## REVIEW COMMENT AND RESPONSE LOG

| <b>Project Title:</b><br>Glenwood Center |                                                | <b>Type of Review:</b><br>Design Review   |

DSRFY2026 – 0015; 4983, 5111 N. Glenwood St., and W Chinden Blvd.

| REVISIONS |               |          | GLENWOOD CENTER<br>GARDEN CITY, IDAHO                                                                       |  |
|-----------|---------------|----------|-------------------------------------------------------------------------------------------------------------|--|
|           |               |          | SHEET NO. C3.0                                                                                              |  |

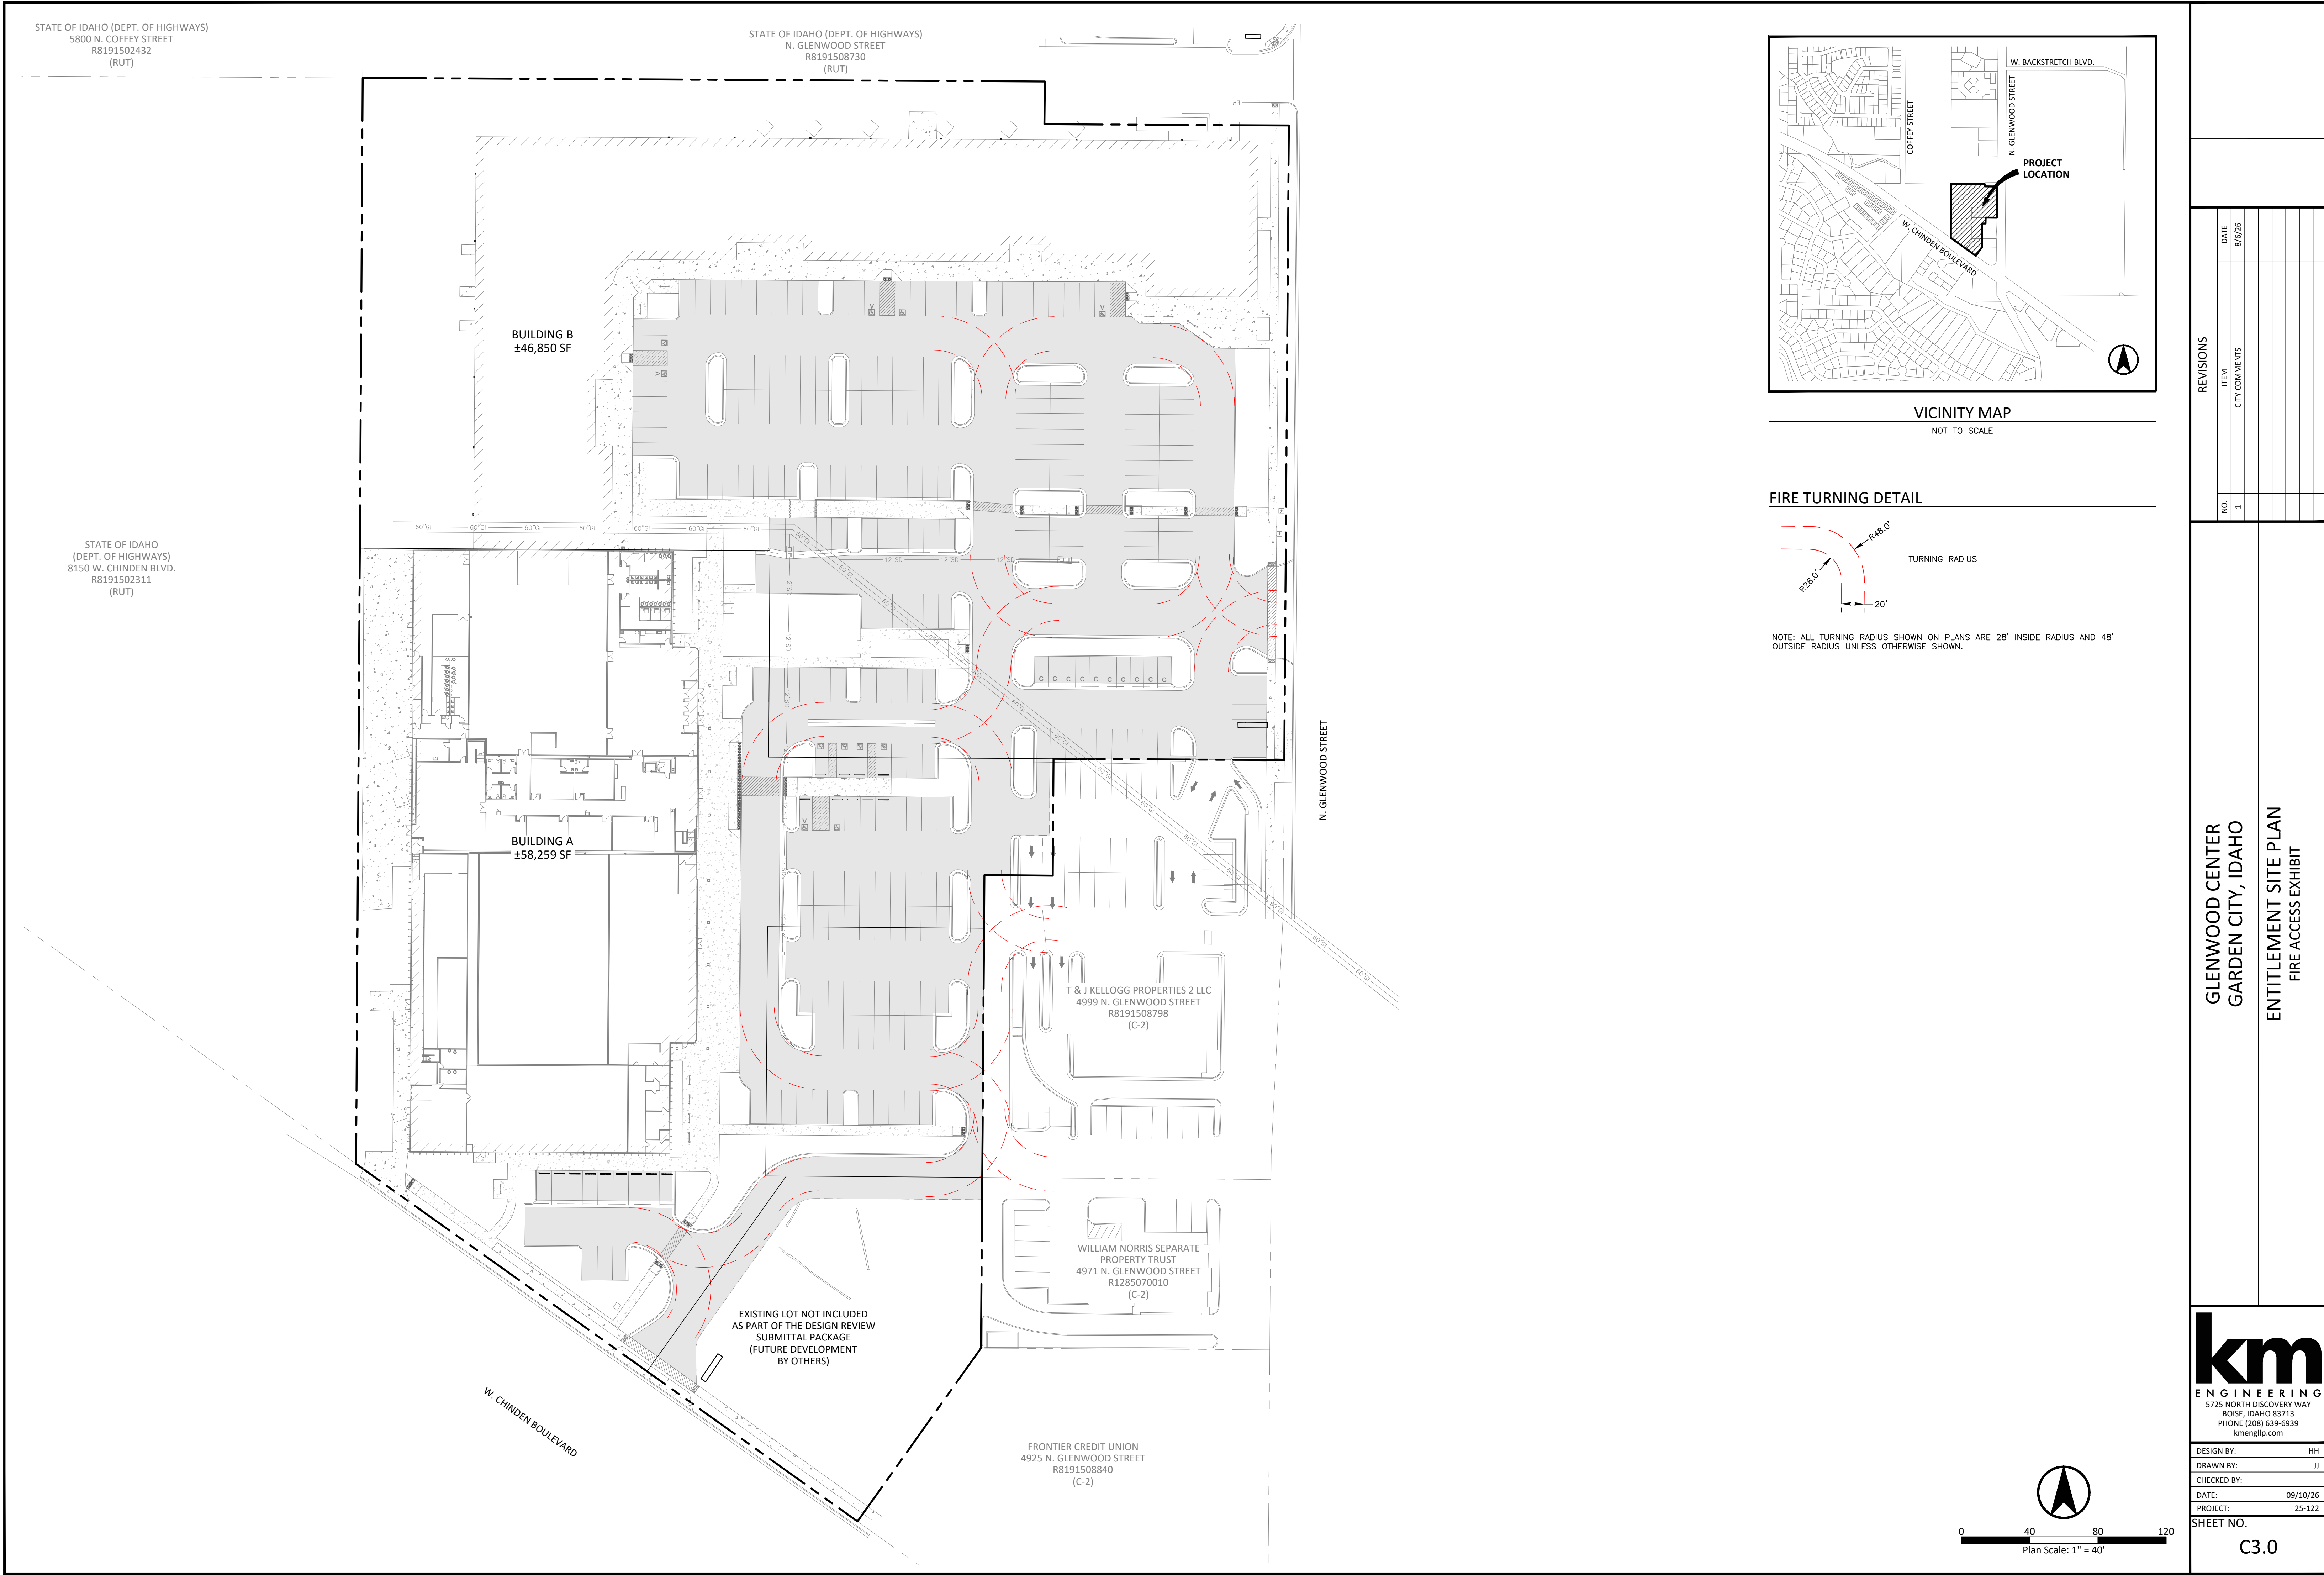
| 6 | 8-4E-4 | <p>"Not enough information"</p> <div> <div>8-4E-4 Internal<br/>Circulation<br/>Standards</div> <div>May not be<br/>compliant</div> <div> <p>Driveways, aisles and turnaround areas, when required for fire and refuse access, shall meet the following standards:</p> <ol style="list-style-type: none"> <li>1. Have a minimum vertical clearance of thirteen feet six inches (13'6") for their entire length and width.</li> <li>2. Have a minimum width of twenty feet (20'). <b>Not enough information</b></li> <li>3. The design of internal circulation should be integrated with the overall site design and adjacent properties, including the location of structures, pedestrian walkways and landscaping.</li> </ol> </div> </div>                                                                                                                                                                                                                                                                                                                                                                                                                                                                                                                                                                                                                                            | <p>See entitlement site plan sheets C1.1 and C1.2 for site plan dimensions. See sheet C3.0 for fire access exhibit.</p>                                                                                                                                                                                                                                                                                                                                                                                                                       |
